THE CITY OF FRESNO

ADDENDUM NO.3

Fresno Fire Department Fire Station No.15 & 17 Bid File Number 2480

ADDENDUM # 4 AD 4.2

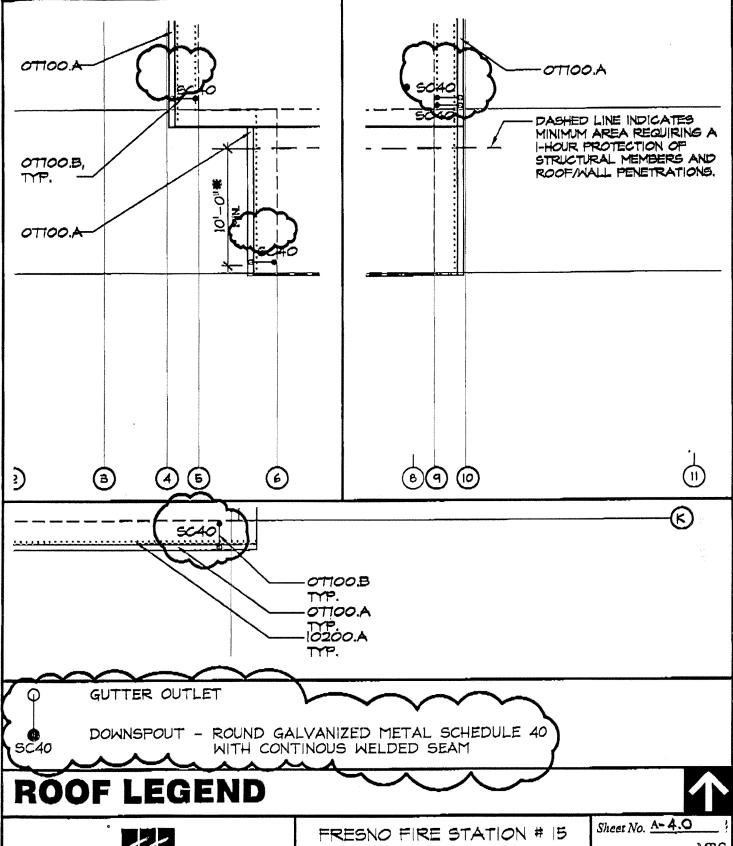
Add Note to Title Block as indicated on AD #4.2.

ADDENDUM#4 AD# 4.4

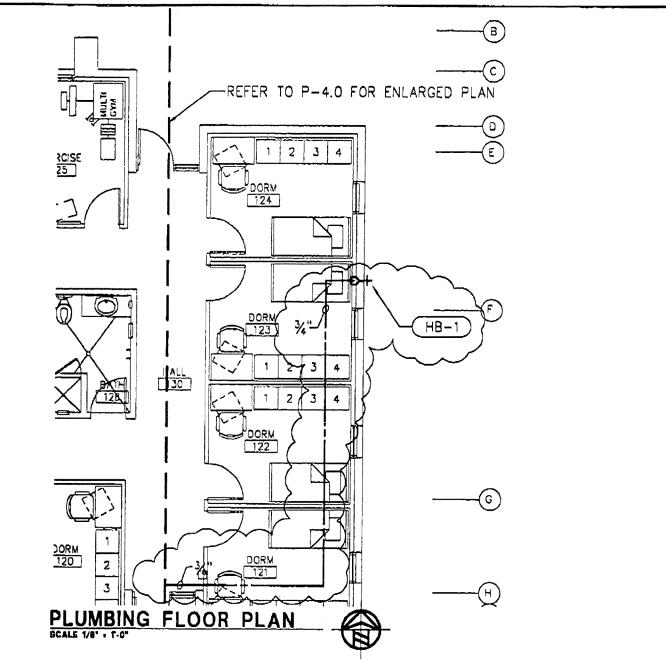
Revise PLUMBING FIXTURE SCHEDULE as indicated. Refer to AD #4.4.

ADDENDUM#4 AD# 4.6

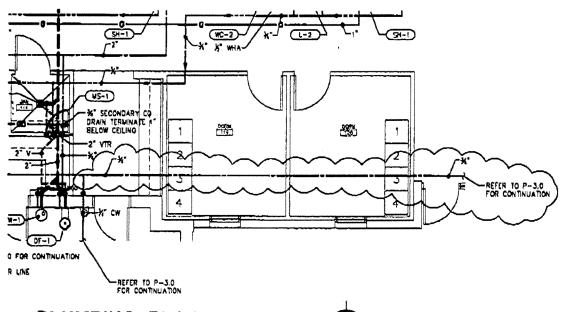
Add Hose Bib to East wall as indicated. Refer to AD #4.5.

PARTIAL PLAN OF FULL SHEET E-2.0

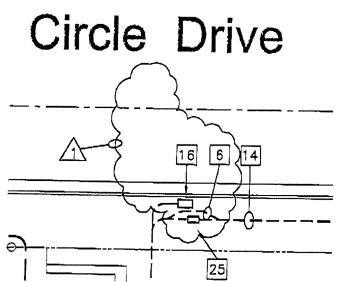
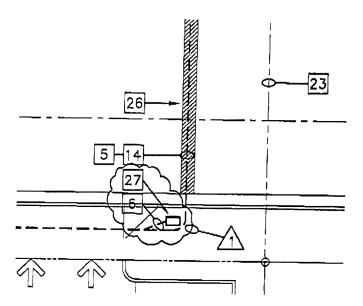
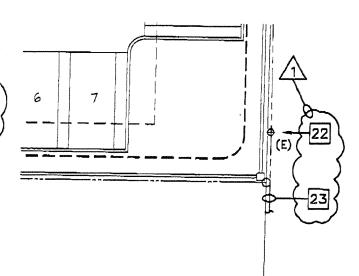
Telephone service and pull-box revisions as indicated. Refer to AD #4.6a.

- 6. (2) 4" TELEPHONE SERVICE CONDUITS PER SBC REQUIREMENTS.
- 27. INSTALL (N)17"X30" PULL BOX PER SBC REQUIREMENTS.

ADDENDUM # 4 AD 4.8

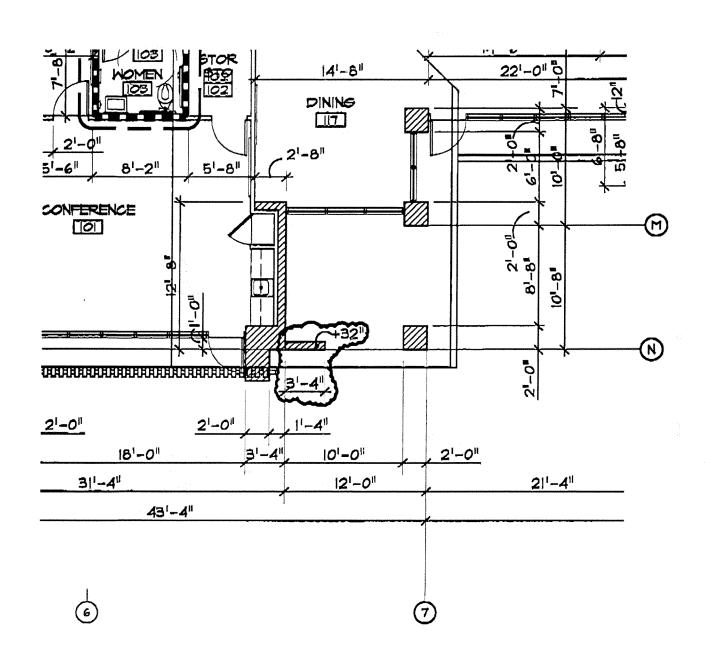
Add 32" high screen wall as indicated. Refer to AD #4.8.

Sheet No. A-2.1/8-E 2012

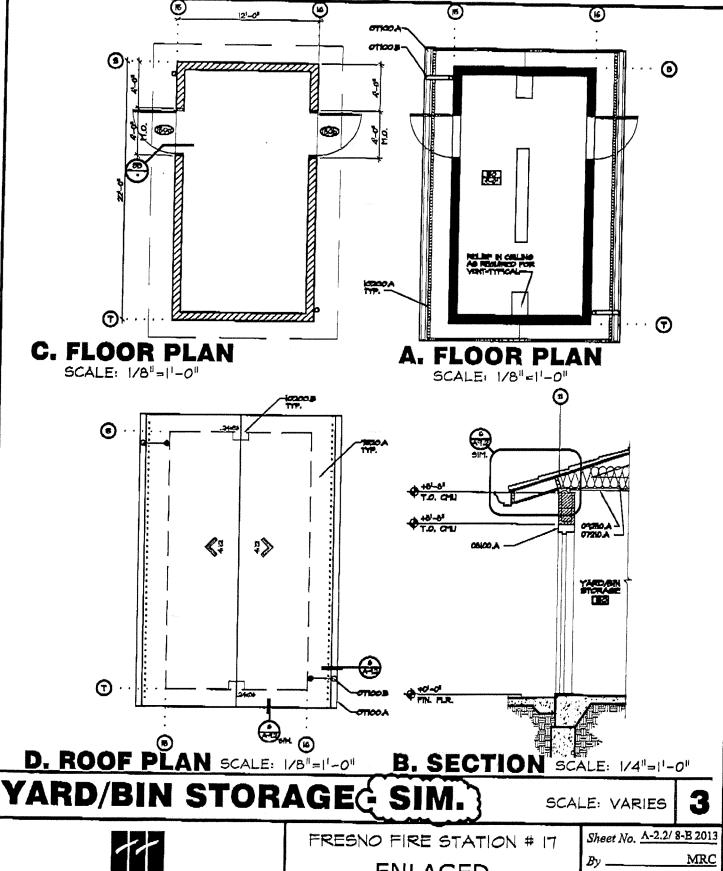
Dimension 32" high screen wall as indicated. Refer to AD #4.9.

APDENDUM #4 AD#4.13

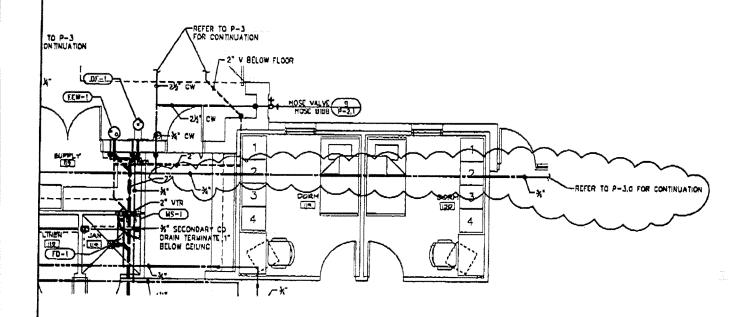
Add Hose Bib to East wall as indicated. Refer to AD #4.13.

10512 NORTH MAPLE
FRESNO, CALIFORNIA 93720
ADDENDUM *4 AD# 4:14

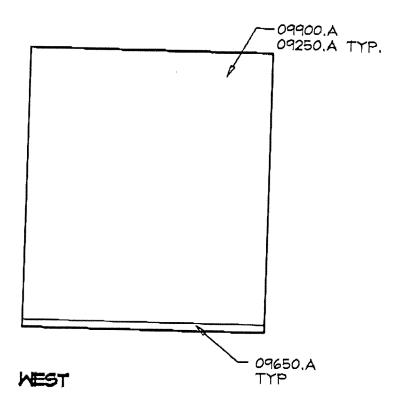
Add Hose Bib to East wall as indicated. Refer to AD #4.14

ADDENDUM # 4 AD # 4,18

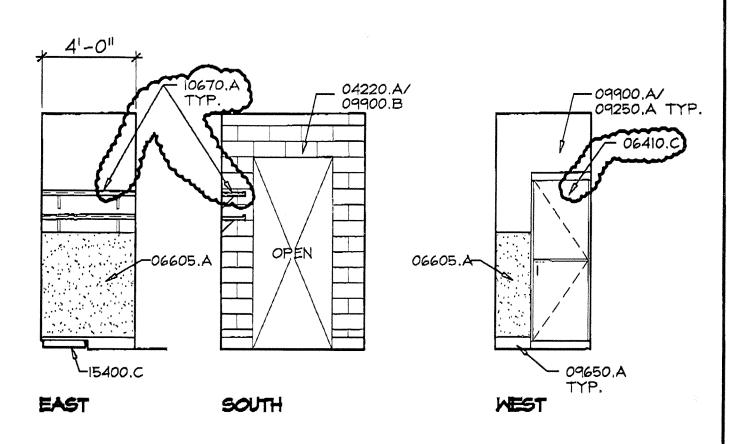
Add General Exhaust System chases, grilles and accessories as indicated. Note dimensional changes. Refer to AD #4.18.

ADDENDUM # 4 AD # 4.19

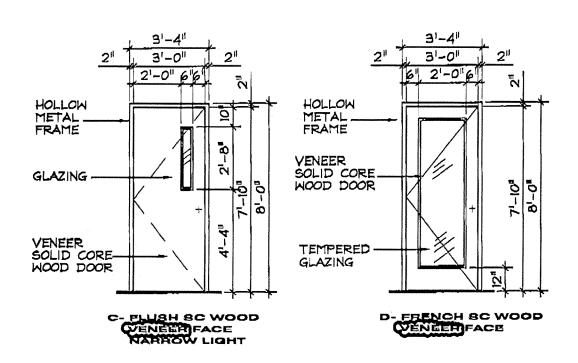
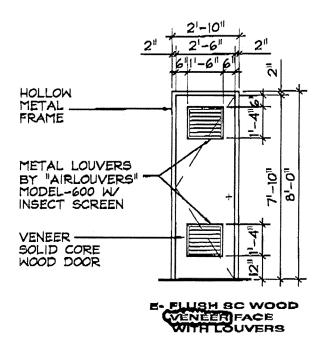
Revise Keynotes as indicated. Refer to AD #4.19.

ADDENDUM # 4 AD # 4.20

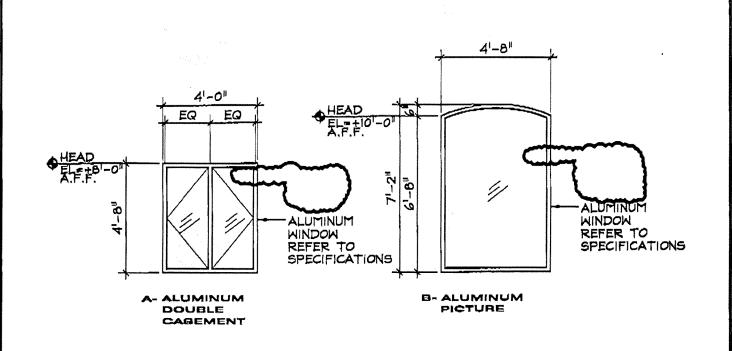
DOOR TYPES – Change indicated doors to Wood Veneer. Refer to AD #4.20 WINDOW TYPES – Remove notes indicating glazing types as indicated. Refer to AD #4.21, 4.22, 4.23 and 4.24

ADDENDUM # 4 AD # 4,25

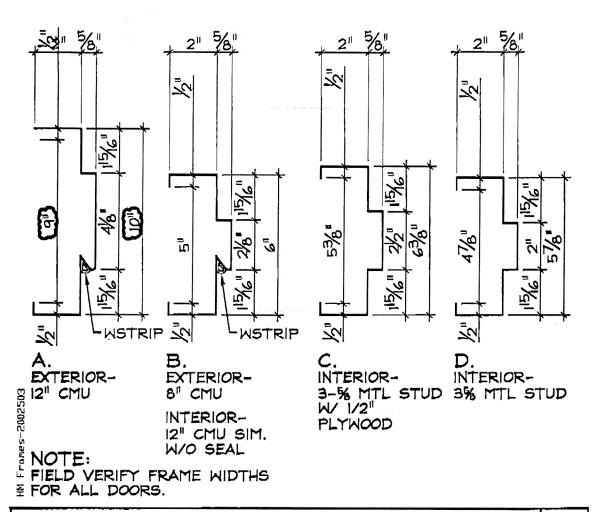
Revise dimensions of metal frames as indicated. Refer to AD #4.25.

TYP. (NOLL-BRG) INTERIOR M.S. BRACING

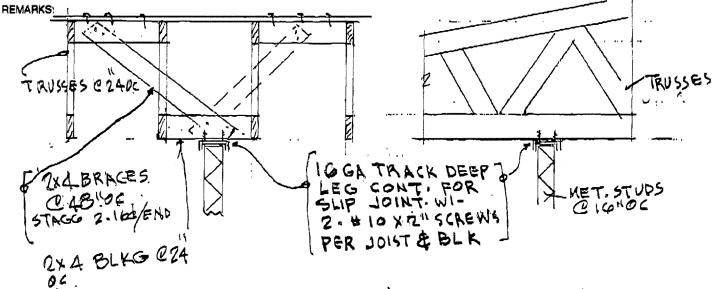
BID QUESTIONS FOR: (X) Fire Station No. 15 (X) Fire Station No. 17 ATTENTION: BOB CALLISTRO, BUYER	(FOR CITY OF FRESNO USE ONLY) QUESTION No:
FROM:	DATE: 4/5/04 PHONE No: 539-212-466 FAX No: 539-252-5338
QUESTION: DETAIL 3/SII GHOWS COME STRIKTINGS. PLEASE PROVI BRACED TO A WOOD ZOOF.	
ANSWER: SEE ATTACHED DETAIL I	EROM CM HALIF ENGINEERING
RESPONSE BY: KIEK VAN CLEAVE NCLUDED IN ADDENDUM NO.	DATE: 5/7/04 DATE:

ACCESIBILITY DETAIL

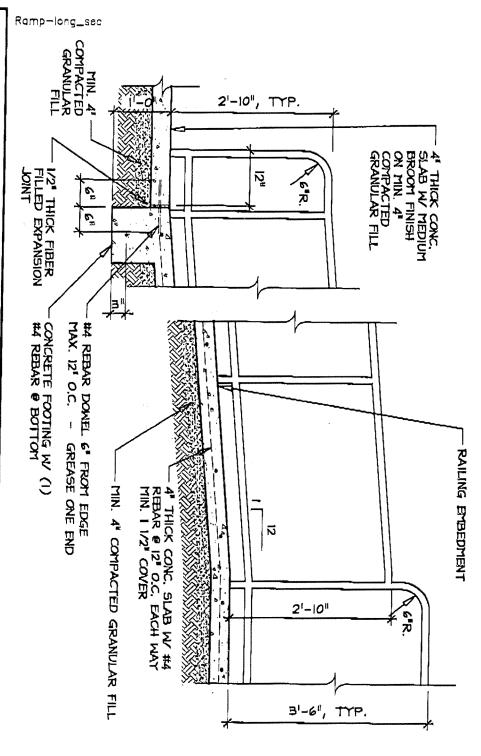
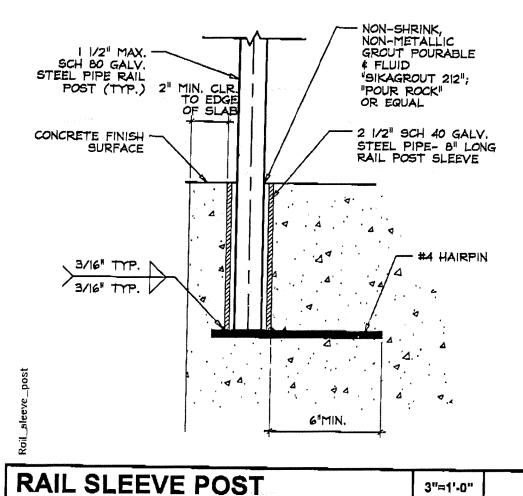
FAA# (339 PI)	
BD QUESTIONS FOR:	(FOR CITY OF FRESNO USE ONLY)
Fire Station No. 15 () Fire Station No. 17	DATE: 5/6 REVIEWED BY:
ATTENTION: BOB CALLISTRO, BUYER	RESPONSIBLE FOR RESPONSE: [] CITY [] CONSULTANT
FROM:	DATE: 5-6-04
COMPANY: L.C. NELSON & SOUS, INC	PHONE No: 896-1443
CONTACT PERSON: ERLY JENSEN	FAX No: 896-8609
	STAIRS OF EAST PARK E PROVIDE DETAILS G'REQUIREMENTS!
ANSWER: SEE ATTACHED RAILING STAIRS TO THE REINFORCE IN ALL RESPECTS, INCLU CITY OF FRESHO & CT	DING ENLY TO APPLICABLE
RESPONSE BY: KIEK VAN CHEWE	DATE: 5/7/04
NCLUDED IN ADDENDUM NO.	DATE:

Sheet No.
 A-9.0/ 8.

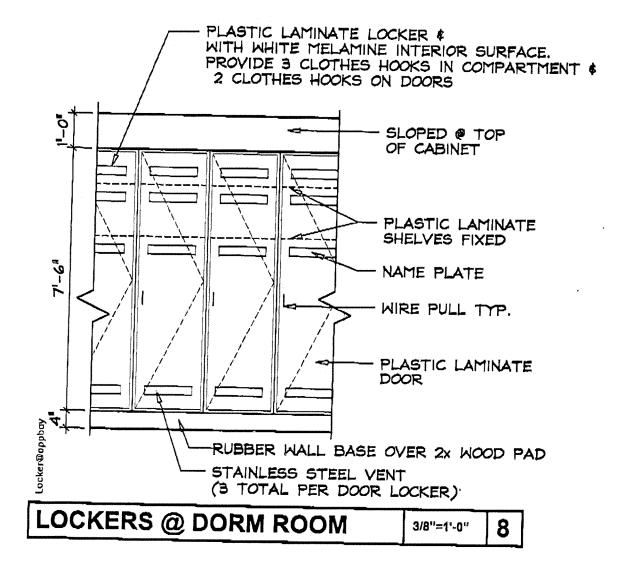
BID QUESTIONS FOR: (~) Fire Station No. 15 (~) Fire Station No. 17 ATTENTION: BOB CALLISTRO, BUYER	(FOR CITY OF FRESNO USE ONLY) QUESTION No:
FROM: -LOUN PICHELI CONTACT PERSON: -LOUN PICHELI	DATE: <u>5[09]04</u> PHONE No: <u>(559)</u> 252-4600 FAX No: <u>(559)</u> 252-5058
SPECIFY. CHARE DEC	SPAD TOESO METAL SU-OUT LOCKERS NO TIOM MALLUDED PLEASE LOCKERS IN DORM SMS. MEY ASK DESCRIPED AS ADJUNTE TURN OUT LOCKERS)
ANSWER REFER TO SPEC SECTION (64) DETAIL FOR PLAN RORM HOCKERS REFER TO SPEC SECTION 10500 IN TO METAL TURNOUT LOCKERS.	
RESPONSE BY: KIEK VAN CLEAVE	DATE: <u>5/7/04</u> DATE:
